CATEGORY: Recommended on all Bodymakers featuring Microdomer upgrading to special studs

NOTE: For further information regarding this Technical Bulletin please contact either of the contacts below quoting Technical Bulletin number **TB5000-075** and your machine Serial Number. A complete library of technical bulletins is available on the company web site.

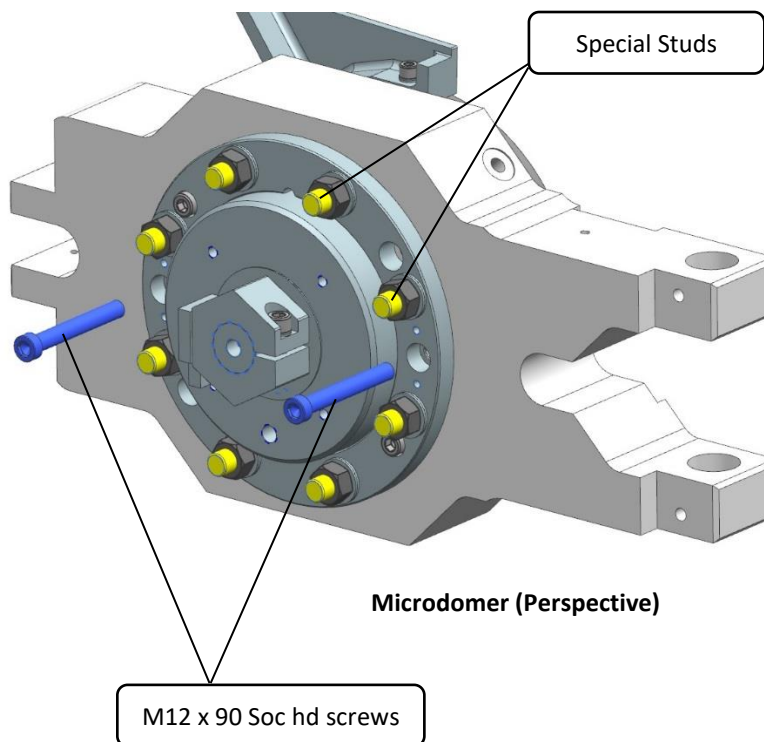
Summary: CarnaudMetalbox Engineering Ltd recommends the removal of 2 off M12 x 90 socket head screws, from the Dome Station assembly as they are NOT required during production ONCE the 8 off special studs have been fitted to the Dome Station. The M12 x 90 soc hd screws are an optional feature to retain the Microdomer in the Dome Door while removing the special studs.
